AMENDMENT OF SOLICITATION/MODIFICATION OF CONTRACT			1. Contract Number	Page of Pages 1 59	
2. Amendment/Modification Number No. 4	3. Effective Date See Block 16C	4. Requisition/Purchase Request No.	5. Solicitation Caption: Columbia Heights Streetscape

**DCKA-2008-B-0103
Columbia Heights Streetscape Contract
(14th Street Core Area and Reconstruction of Park Road)
AMENDMENT NO. 4**

RESPONSE TO QUESTIONS/COMMENTS FROM PROSPECTIVE BIDDERS

CONCRETE PAVEMENT JOINT PLAN
INTERSECTION PARK RD. & 14TH ST.

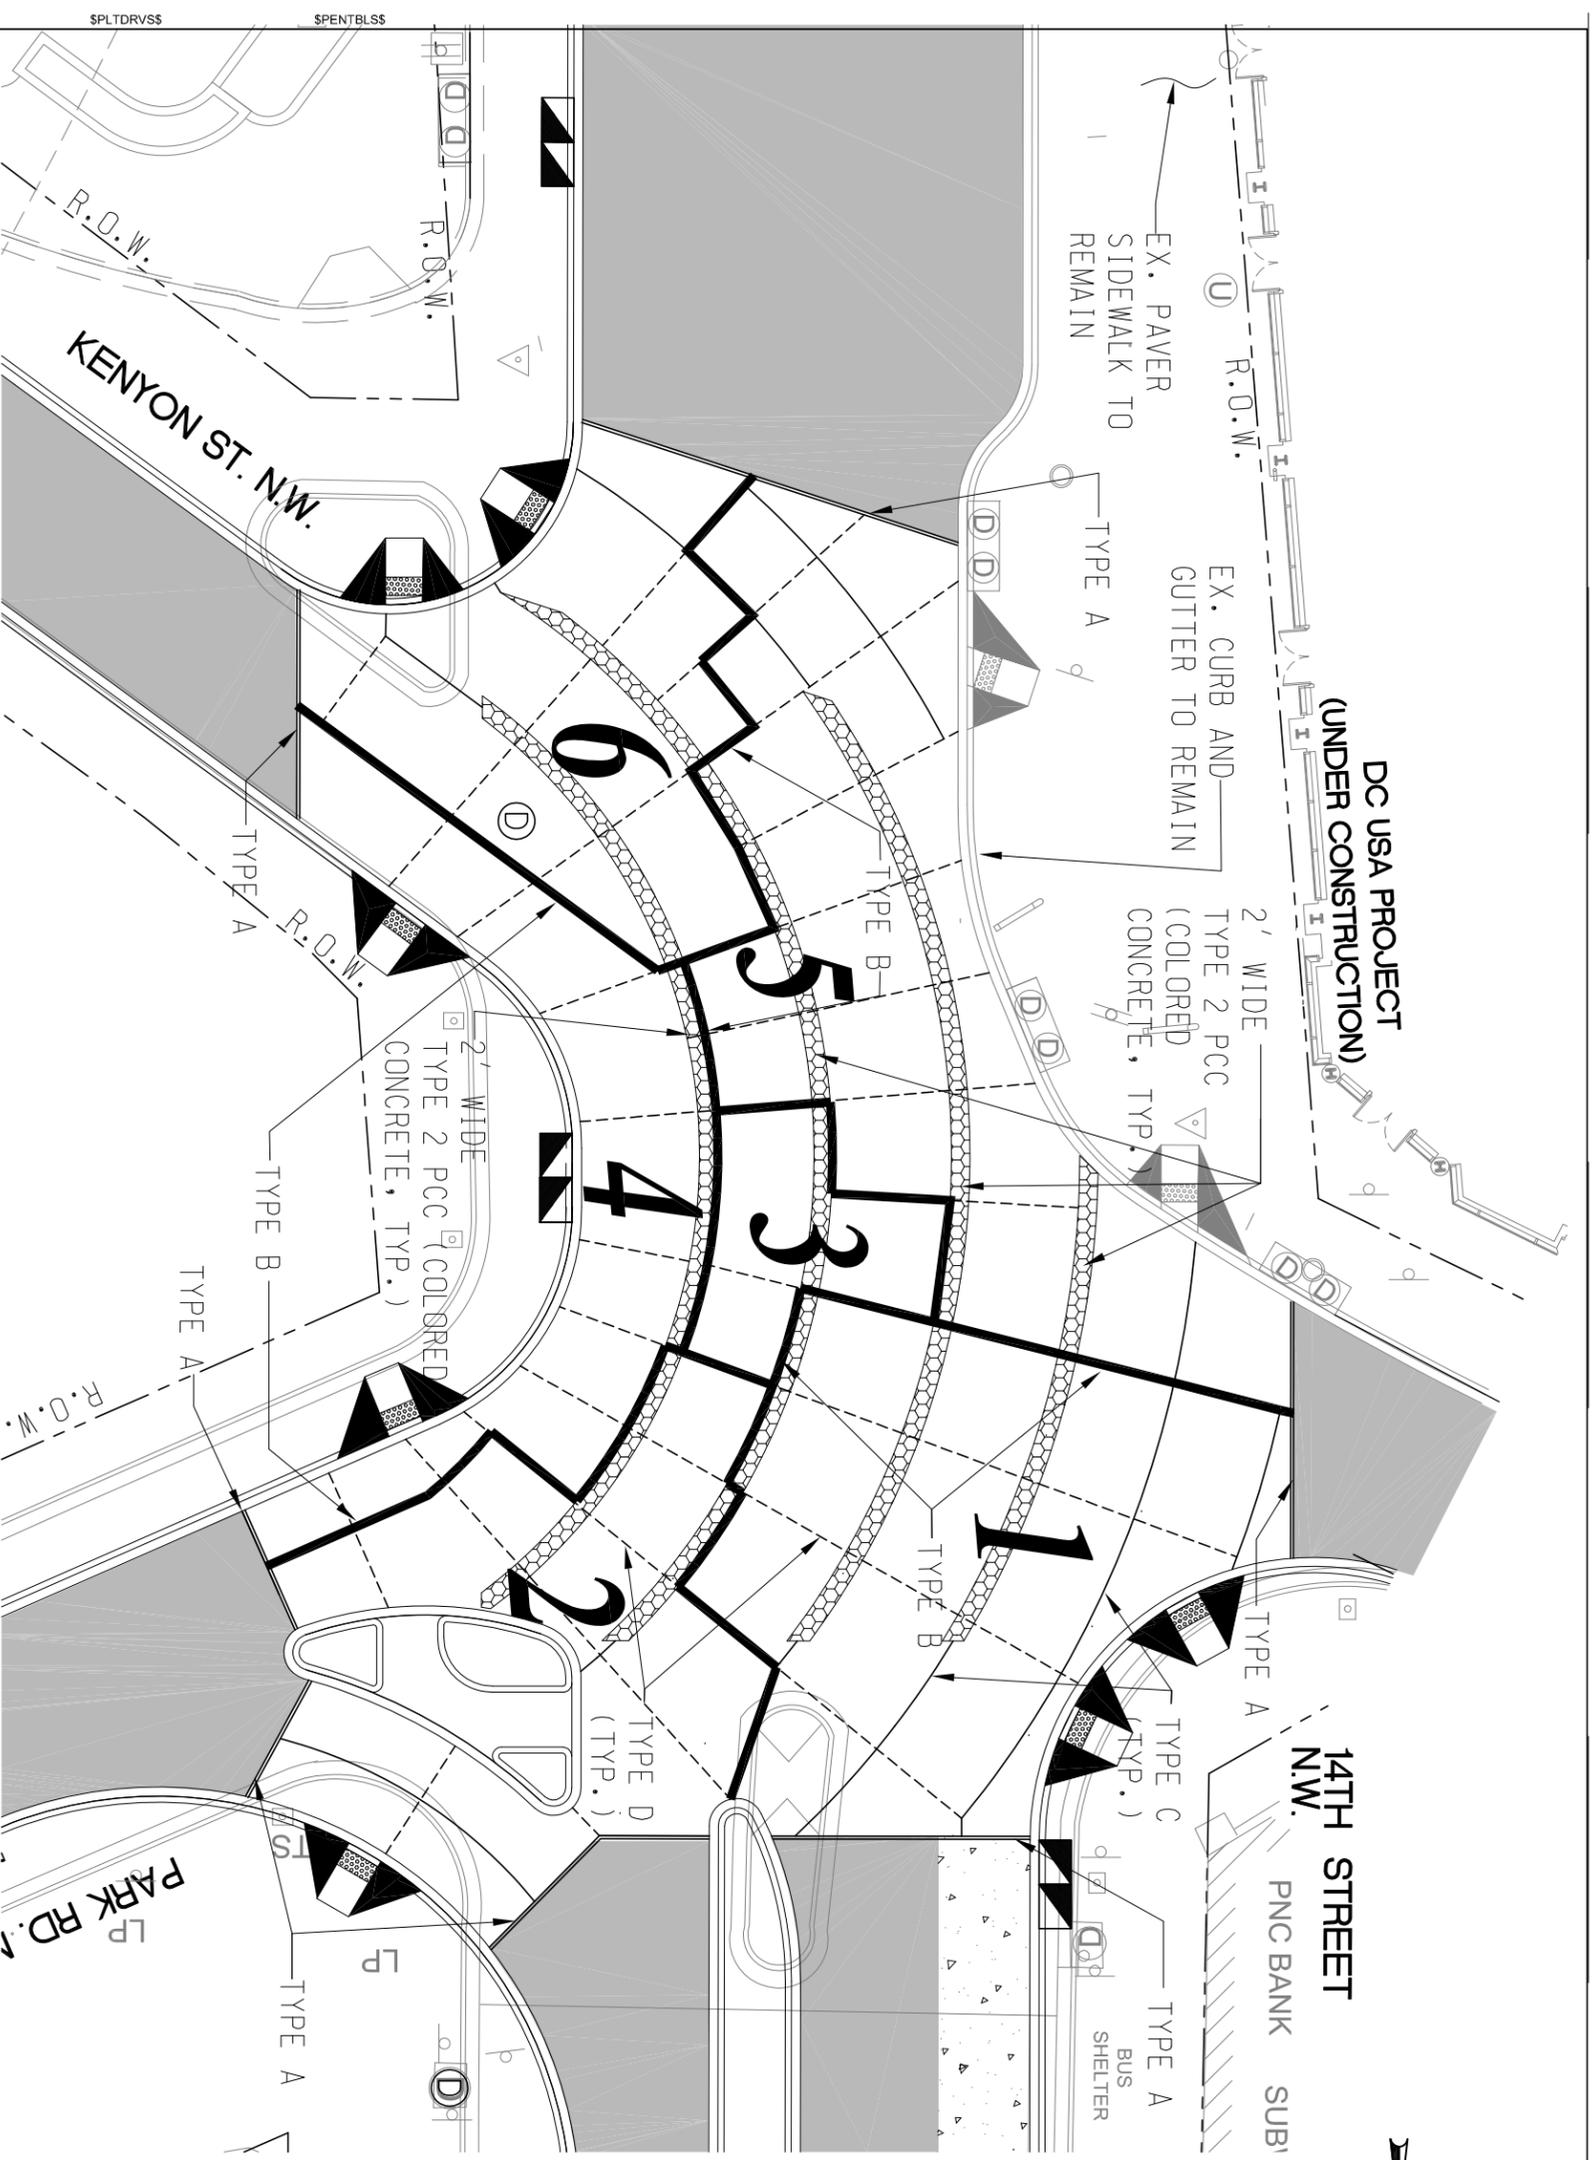
COMMENT: **Concrete Pavement Joint Plan – Intersection Irving St & Park Road**
(Sheets 27-B & 27-C)

The transverse joints do not line up, who will be responsible when the pavement fails?

RESPONSE: **Revised plan sheets showing the revised transverse joints which minimize the number of non-aligned joints are being issued in this addendum.**

DELETE Plan Sheet C-25C “Concrete Pavement Joint Plan Intersection Park Road &14th Street”.

ADD Plan Sheet C-25CR “Concrete Pavement Joint Plan Intersection Park Road &14th Street”. (1 page attached)
